Applicant : William R. Heneveld, Sr.
Appln. No. : 10/635,104
Page : 11

REMARKS

FIG. 7

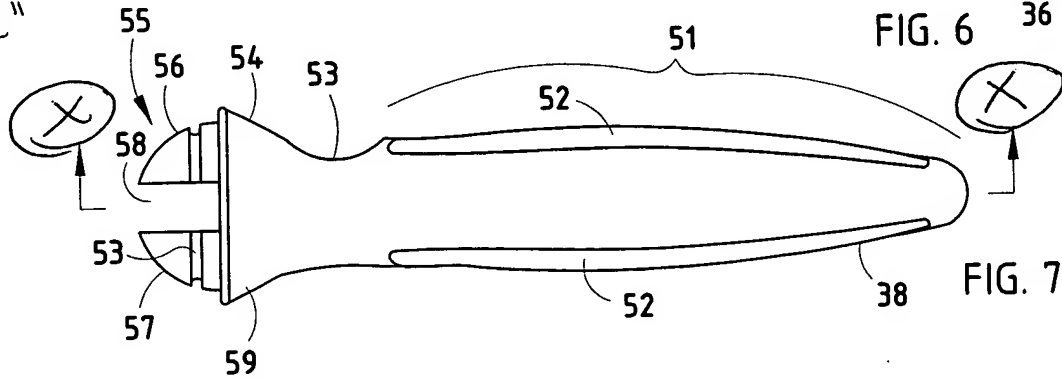
Attached is an amended Fig. 7 which now labels the cross section as "X-X," which is referred to in the specification on page 4, line 7. No new subject matter is included. Applicant appreciates the Examiner's detailed review. The amended drawing is attached to the present papers and is prepared as a formal set of drawings.

Cross section
now labeled
"X-X"
